**AMENDMENTS TO THE DRAWINGS:**

### **REMARKS**

ANNOTATED MARKED-UP DRAWING

FIG.1

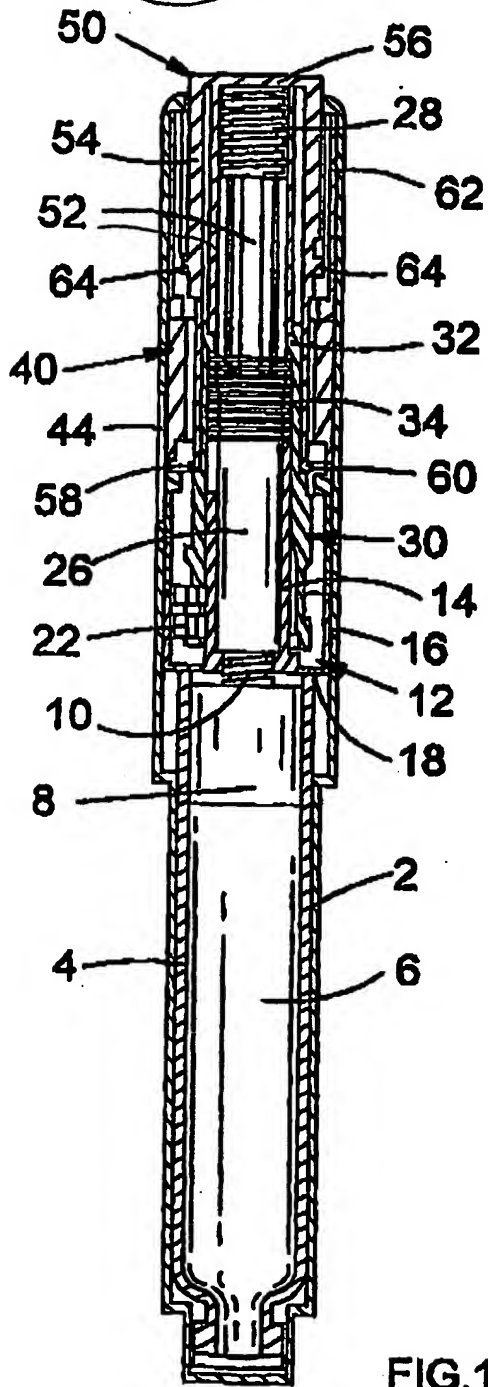
The attached replacement sheet of drawings include the following changes to the drawing figures: FIG. 1 is amended to properly indicate the first cylinder 52, which is described on page 10, lines 14-26 of the originally filed application. Accordingly, Applicants submit a replacement sheet and an annotated sheet showing the drawings changes to FIG. 1.
